SUBJECT: ST. LUCIE UNIT 1 - ISSUANCE OF AMENDMENT RE: REACTOR COOLANT  
 SYSTEM PRESSURE/TEMPERATURE LIMITS (TAC NO. M92412)

AMENDMENT NO. 141 TO FACILITY OPERATING LICENSE NO. DPR-67 - ST. LUCIE, UNIT 1

SAFETY EVALUATION BY THE OFFICE OF NUCLEAR REACTOR REGULATION

**FIGURE 3.1-15**  
**MAXIMUM ALLOWABLE HEATUP AND COOLDOWN RATES,**  
**SINGLE HPSI PUMP IN OPERATION**  
**(23.6 EFY)**

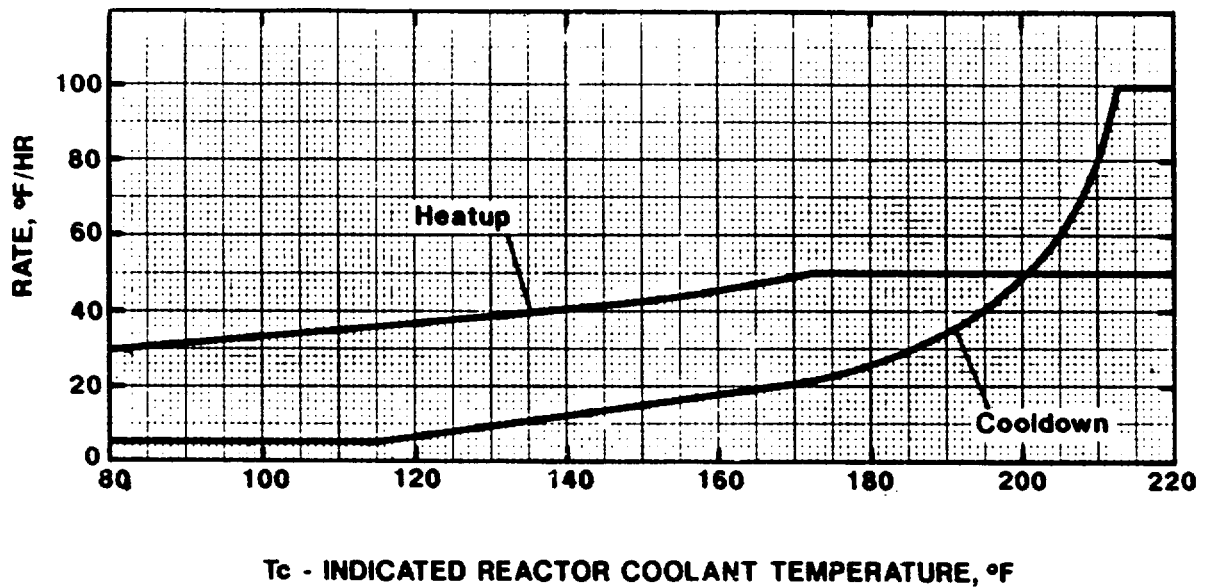
This amendment will extend the applicability of the current Reactor Coolant System (RCS) Pressure/Temperature Limits and maximum allowed RCS heatup and cooldown rates to 23.6 Effective Full Power Years (EFPY) of operation. In addition, administrative changes were proposed for TS 3.1.2.1 (Boration Systems Flow Paths-Shutdown) and TS 3.1.2.3 (Charging Pump-Shutdown) to clarify the conditions for which a High Pressure Safety Injection pump may be used.

\* The flow path from the RWT to the RCS via a single HPSI pump shall only be established if: (a) the RCS pressure boundary does not exist, or (b) no charging pumps are operable. In the latter case: 1) all charging pumps shall be disabled; 2) heatup and cooldown rates shall be limited in accordance with Figure 3.1-1b; and 3) at RCS temperatures below 115°F, any two of the following valves in the operable HPSI header shall be verified closed and have their power removed:

**FIGURE 3.4-2a**  
**ST. LUCIE UNIT 1 P/T LIMITS, 23.6 EFY**  
**HEATUP AND CORE CRITICAL**

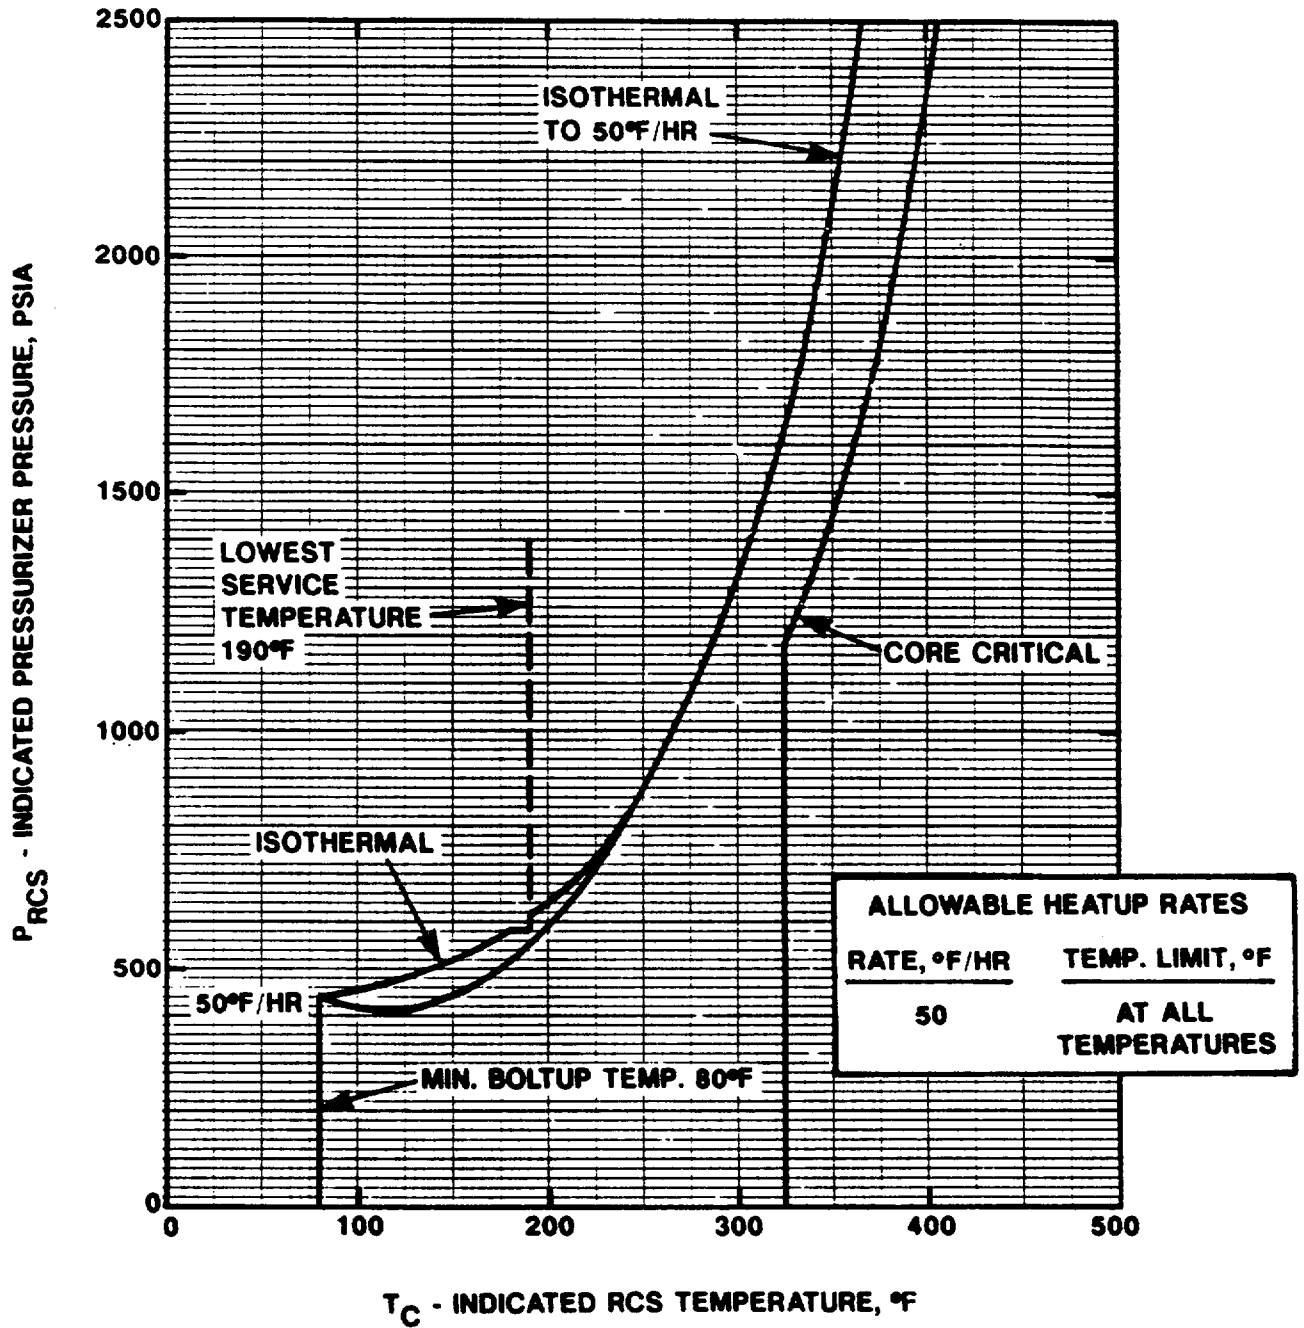
The staff judges that a difference of  $0.5^{\circ}\text{F}$  between the licensee's ART of  $191^{\circ}\text{F}$  and the staff's ART of  $191.5^{\circ}\text{F}$  is negligible. Further, since the licensee back-calculated the fluence in this application based on the ART of  $191^{\circ}\text{F}$ , which is the same as that appeared in the 1989 P/T limits submittal, the proposed P/T limits for heatup, cooldown, and hydrotest are identical to the current P/T limit curves and meet the beltline material requirements in Appendix G of 10 CFR Part 50. The only changes made in Figure 3.4-2a and Figure 3.4-2b by the licensee are EFPY values in the legends associated with these P/T limit curves.

The staff concludes that the proposed P/T limits for the reactor coolant system for heatup, cooldown, leak test, and criticality are valid through 23.6 EFPY because the proposed limits conform to the requirements of Appendices G and H of 10 CFR Part 50. The proposed P/T limits also satisfy GL 88-11 because the method in RG 1.99, Rev. 2 was used to calculate the ART. Hence, the proposed P/T limits may be incorporated into the St. Lucie 1 Technical Specifications.

**FIGURE 3.4-3  
ST. LUCIE UNIT 1, 23.6 EPY  
MAXIMUM ALLOWABLE COOLDOWN RATES**

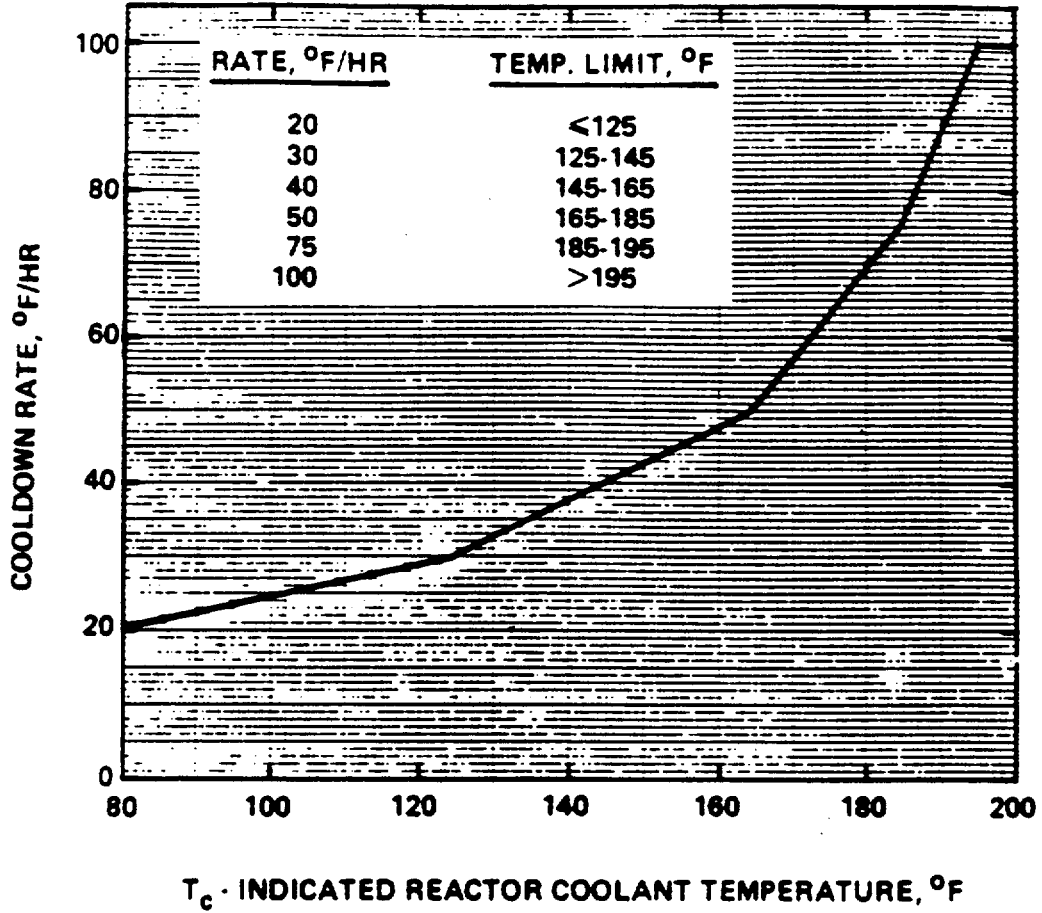
**NOTE: A MAXIMUM COOLDOWN RATE OF  
100°F/HR IS ALLOWED AT ANY  
TEMPERATURE ABOVE 195°F**
